# **LMS2, Service Bulletin, LASX065**

## **Harness Update**

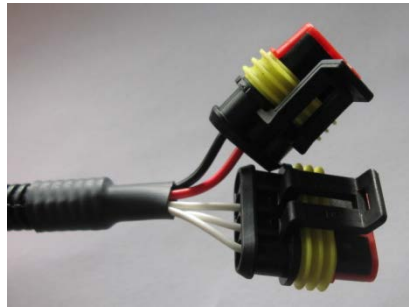
This SB relates to a change in the system harness (P/N: LMS2-LASX065). The revision 2 harnesses have updated connectors which provide greater reliability (mating force and environmental) as well as improved manufacture speed and yield.

- The Forward/Reverse harness still contains blue and green wires; however it is fitted with a 3 pin male connector with female terminals. Position 3 is for the stabiliser (when fitted). It mates with a 3 pin female connector with male terminals in the system harness.

- The control panel harness is a 4 pin female connector with male terminals. The harness is still fitted with orange, purple and yellow wires. It mates with a 4 pin male connector on the system harness.

The camera power connector is fitted with a 2 pin connector.
